ENGINEERING CHANGE PROPOSAL

MODIFICATION P00002

13. TITLE OF CHANGE
NEW AEGR INTERFACE DRAWINGS

| 15. CONFIGURATION ITEM NOMENCLATURE ARMY EMBEDDED GLOBAL POSITIONING SYSTEM RECEIVER (AEGR) : M1A2 SEPTANK | | | 17. IN PRODUCTION | |

PART NO. 12991884

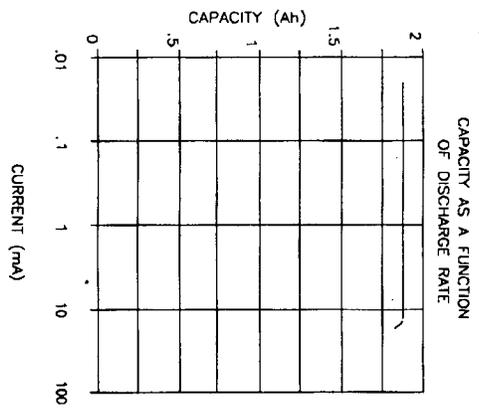
19. DESCRIPTION OF CHANGE
 1. Add two new drawings
 2. Update performance specification.

20. NEED FOR CHANGE
 1. New drawings will establish and maintain compatibility between co-functioning items. Also it will control interface designs.
 2. Reflect addition of interface drawing.

| 13. DESCRIPTION OF REVISION <p style="text-align: center;">SEE CONTINUATION NOR SHEETS 2 THRU 3 FOR NEW DRAWING</p> | | | |

| NOTICE OF REVISION (NOR) THIS REVISION DESCRIBED BELOW HAS BEEN AUTHORIZED FOR THE DOCUMENT LISTED. | | 1. DATE (YYMMDD) 000113 | Form Approved OMB No. 0704-0188 |
|---|--|--|---|
| 13. DESCRIPTION OF REVISION ADD: NEW SECTION 3.3.3.3 " 3.3.3.3 <u>Interface Configuration</u> : Interfaces are defined on drawings 12991884,12438560 and in this specification. " | | | |
